**Subject: EnergyConnect (NSW - Western Section) – SSI 10040**

## ATTACHMENT A BCD Assessment Summary for EnergyConnect (NSW – Western Section) Environmental Impact Statement (SSD 10040)

## **ATTACHMENT B Detailed comments for EnergyConnect (NSW - Western Section) Environmental Impact Statement (SSI 10040)**

Example of category 1 land mapped on Renmark Road roadside and Lot 5487/768396 that requires further justification (blue circle).

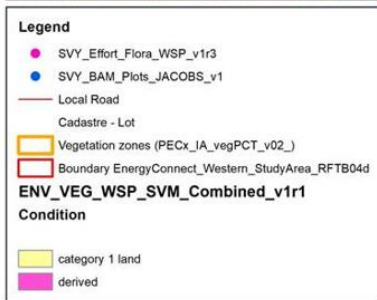
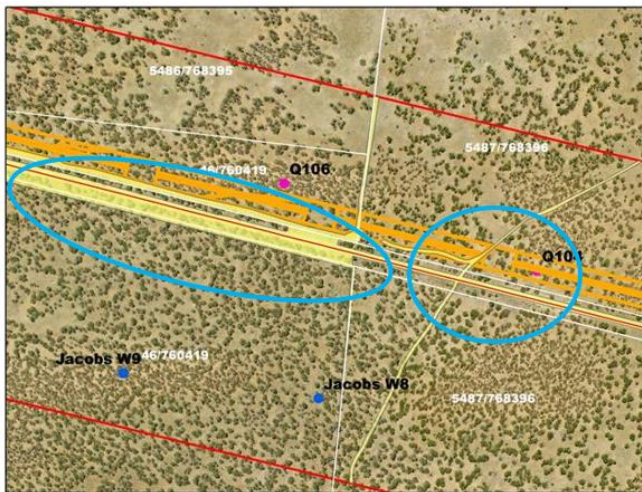
Areas of vegetation labelled as 'no impact' in the digital data (PECx\_IA\_vegPVT\_v02) where maintenance activities may occur have not been assessed.

Some areas of naturally treeless vegetation have not been assessed. Assumptions about the impact of maintenance on biodiversity are not sufficiently explained to justify exclusion of these areas from the assessment.

For example: South Olary Plain sub-region (Lot 9, DP 1255309), mapped as PCT 154 Pearl Bluebush low open-shrubland in the vicinity of Jacobs flora plot W12. Jacobs ecologists described vegetation within this plot as in 'good condition'.

- the specific impacts of maintenance
- if maintenance includes regular vehicle movements across the vegetation
- if weed control is to occur within this area, and if so, what are the impacts on this vegetation and associated threatened species and their habitats?

- *Include areas where maintenance actions will occur in the impact area for the project or justify why ongoing maintenance activities will have **no** impact on biodiversity.*

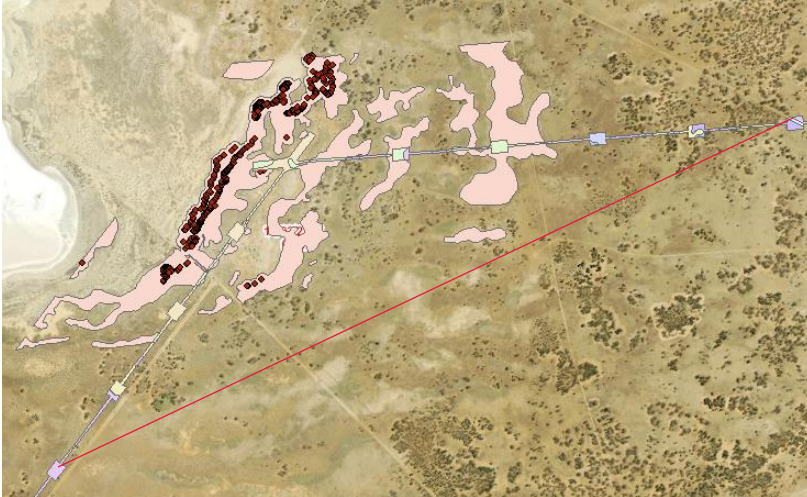
Table 9.14 provides an assessment of the SAI on *Austrostipa nullanulla*, following the *Guidance to assist a decision-maker to determine a serious and irreversible impact* (DPIE, 2019). The assessment addresses most of the SAI criteria.

However, the BDAR states that the proposal was refined to avoid and minimise impacts on *Austrostipa nullanulla*. In fact, there is an opportunity to completely avoid the gypseous rises that are habitat for this species by running the alignment south of this area (see figure below). The EIS does not explain why this option was not feasible.

- Explain why the project alignment cannot avoid the areas of habitat for *Austrostipa nullanulla*.

For example: Lot 500/761443 South Olary Plain PCT 170 not assessed and mapped as derived

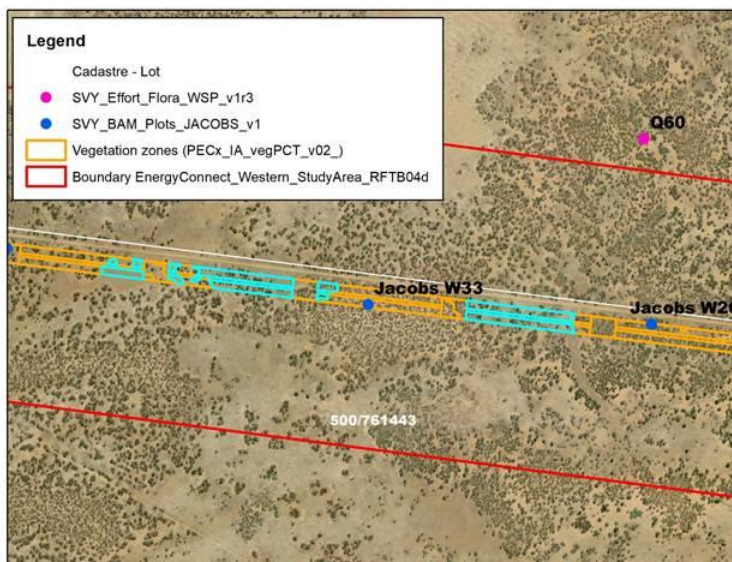
Derived native vegetation communities appear to have been over-estimated.

Derived vegetation is defined in the BDAR as vegetation lacking a canopy stratum (e.g. see PCT 56 page C2.32). This definition does not accord with the definition in the BAM Operational Manual (Stage 1, page 15) that derived (or secondary vegetation) is vegetation that has changed to an alternative stable state as a consequence of land management practices since European settlement. Derived PCTs differ from PCTs that have been modified from their natural state in that the derived PCT is unlikely to revert to the natural state without significant active restoration. Temporary loss of structural elements due to grazing, drought or fire may result in a vegetation with lower vegetation integrity than an intact example without being designated as derived.

It is incorrect to map the boundary of woodlands or open-woodland to the edge of obvious tree canopies. The structure of an open-woodland overstorey is defined as “well separated” trees with a crown cover of 0.25 to 20% (Walker & Hopkins 1990). The equivalent foliage cover is 0.2 - 10% (Table 17 in Hnatiuk *et al.* 2009). That means trees in a mapped woodland polygon can be 100 m apart.

There appears to be native vegetation within the polygons with blue boundaries, which have been designated as derived in the assessment.

- *Demonstrate that vegetation mapped as derived is not an open-woodland or natural structural variant of the relevant PCT, such as where the overstorey is absent due to fire or drought.*
